Office Action Summary

09/752,879

FINAL OFFICE ACTION

FIG. 1

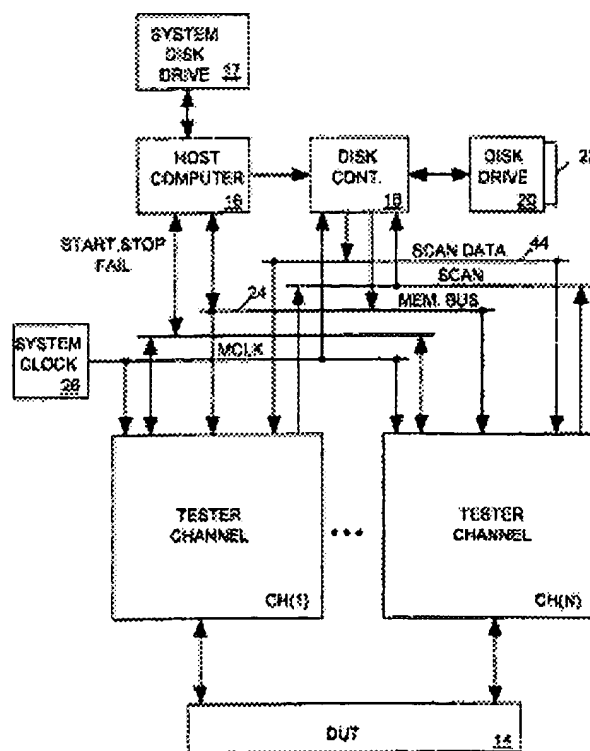
As per **Claims 1, 6, 11, 16**, **Wasson** substantially depicts, in Figs. 1-2 and related description in col. 1 line 10 et seq., the claimed apparatus or system or means circuit comprising: internal data bus (col. 2 line 55, or Fig. 1 numeral 24); plural clusters coupled to said bus with data signal synchronizing means for data signals there-through (Fig. 1 CH1..CHN); test controller coupled to said bus (col. 4 line 45 or col. 6 line 50 et seq., as seen in Fig. 1 Blocks 16 and 18); and a debug or tester or tester unit coupled to said bus (col. 4 line 47 et seq.) wherein the bus is configured to generate system or global control signal (at col. 4 lines 46 et seq.) and each of said plural clusters configured to generate local or separate control signals at col. 4 lines 49 et seq., wherein an IC embeds said ITC, clock controller means and entire tester components within a monolithic integrated circuit, e.g., in Fig. 1 and col. 3 line 45.

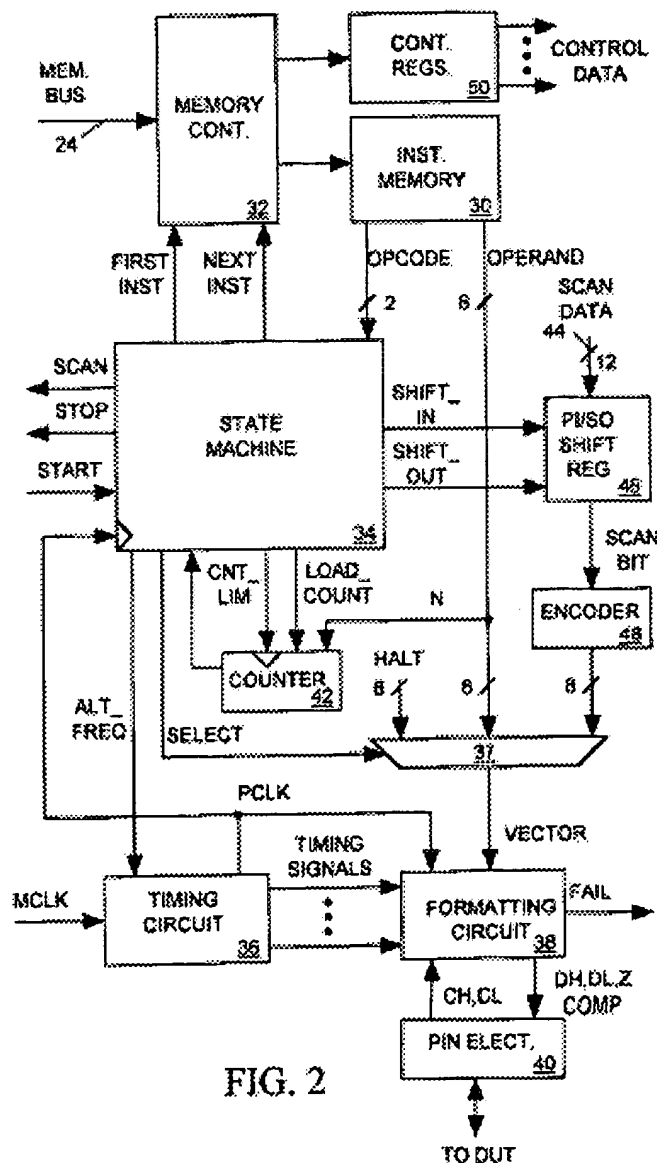
However, Examiner notes that such ITC comprising an instruction register and a test access port finite state machine is part of a design standard as described in IEEE 1149.1, as conceded by Applicants' instant application on page 9 line 4. **Examiner** also notes that **Wasson** teaches the use of a finite state machine in Fig. 2 and memory means to store test instructions in plural channels in, e.g., col. 7 line 4.

Accordingly, such ITC so configured is well known as being part of an integrated circuit, said IC having a self-test feature. It is also well known that some ICs comprise built-in self-testing (BIST) capabilities thereby obviating the need for a bulky/expensive external tester and costly maintenance associated therewith. For instance, **Attaway et al.** incorporates such design approach for a BIST system as depicted in Fig. 4 wherein *interface 10* comprises a *finite state machine 50* and an *instruction register 52*. {See **Attaway et al.**, Id., e.g., col. 3 line 25 for IEEE 1149.1 standard, col. 5 lines 34 for TAP finite state machine, col. 4 line 39 for instruction register, and RAM and *RAM BIST 40*.}

Therefore, it would have been obvious to a person having ordinary skill in the art at the time the invention was made to modify the IC tester of **Wasson** by including therein TAP state machine and instruction register with a BIST system as taught by **Attaway et al.**, because such modification would provide the testing procedure of **Wasson** with a method whereby the testing system not only complies with the IEEE 1149.1 standard but also is cost efficient because such design minimizes test hardware overhead and eliminates operator intervention in test mode. {See **Attaway et al.**, Id., Fig. 4: block 10.}
